ROCK COMMON QUARRY
The Hollow, Washington RH20 3DA

PLANNING APPLICATION WSCC/028/21
ADDITIONAL INFORMATION (1)

OCTOBER 2022

Landscape Masterplan Strategy (Illustrative)
Rock Common Quarry, The Hollow, Washington

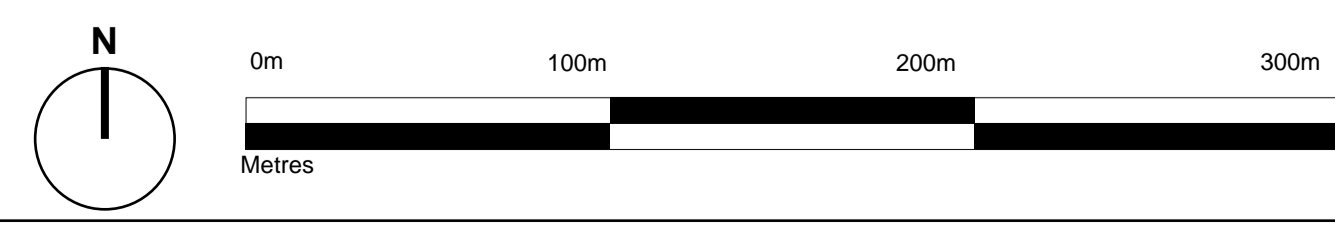
- Natural regeneration would be the preferred method of restoration rather than intensive intervention, but this will still require management to provide the habitat mosaic envisaged by the landscape design strategy: everything from open sand faces to woodland and all successional stages in between. This appears to be the intention of the first landscape objective and applied design principle 3. I would question the need to plant birch and willow, for example, given that they are pioneer species and will readily colonise areas. Biosecurity is critically important, and it would be better to minimise the plant material brought to site unless it is UK sourced and grown and complies with all biosecurity regulations.

2.4 The Landscape Design Strategy, Design Principle 2 limits the anticipated open water swimming, or perhaps kayaking, to the northern pond only. The Landscape Masterplan and Strategy have been updated to remove the proposed shallow vertical face of rock gabions, (to provide additional Sand Martin habitat) from the northern pond where anticipated open water swimming, or perhaps kayaking could be undertaken.

2.5 The Landscape Masterplan and Landscape Design Strategy have been updated to recommend natural regeneration in the short term. Where planting of scrub and tree species is required to achieve the habitat objectives, this would only be considered in the mid-term and would be specified using local provenance stock which complies with all UK plant biosecurity guidance.
